Well Name: BIFF	Well Location: T24N / R10W / SEC 20 / NESE / 36.296001 / -107.912917	County or Parish/State: SAN JUAN / NM
Well Number: 91S	Type of Well: OTHER	Allottee or Tribe Name:
Lease Number: NMNM43442	Unit or CA Name:	Unit or CA Number:
US Well Number: 300453348100S1	Operator: DUGAN PRODUCTION CORPORATION

Notice of Intent

Type of Action: Plug and Abandonment

CONDITIONS OF APPROVAL

Planned P & A Wellbore Schematic

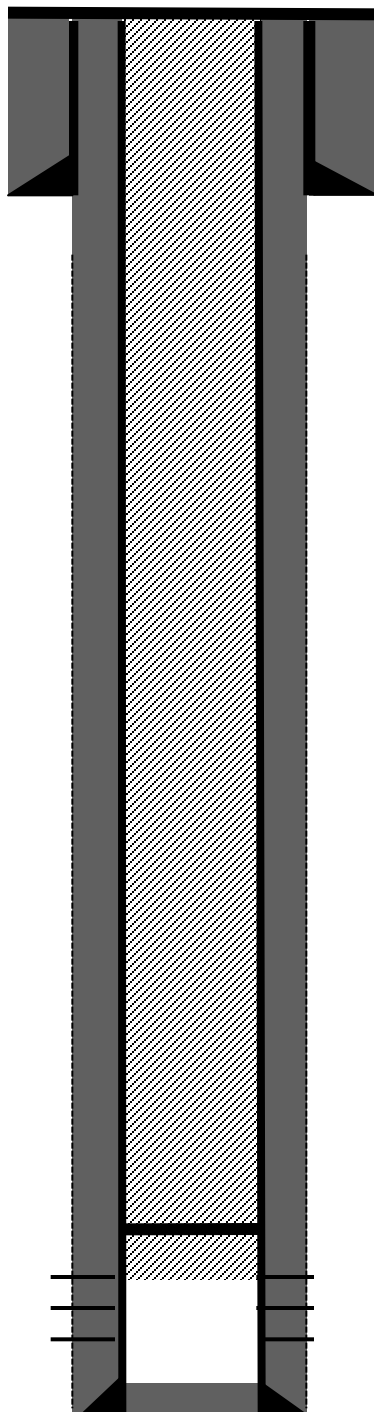
1. Plugging operations authorized are subject to the attached "General Requirements for Permanent Abandonment of Wells on Federal and Indian Lease."
2. The following modifications to your plugging program are to be made:
 - a. Complete wellbore fill up. No changes to the procedure.
3. **Notification:** Farmington Office is to be notified at least 24 hours before the plugging operations commence at (505) 564 7750.

Complete wellbore fill up. No changes to the procedure.
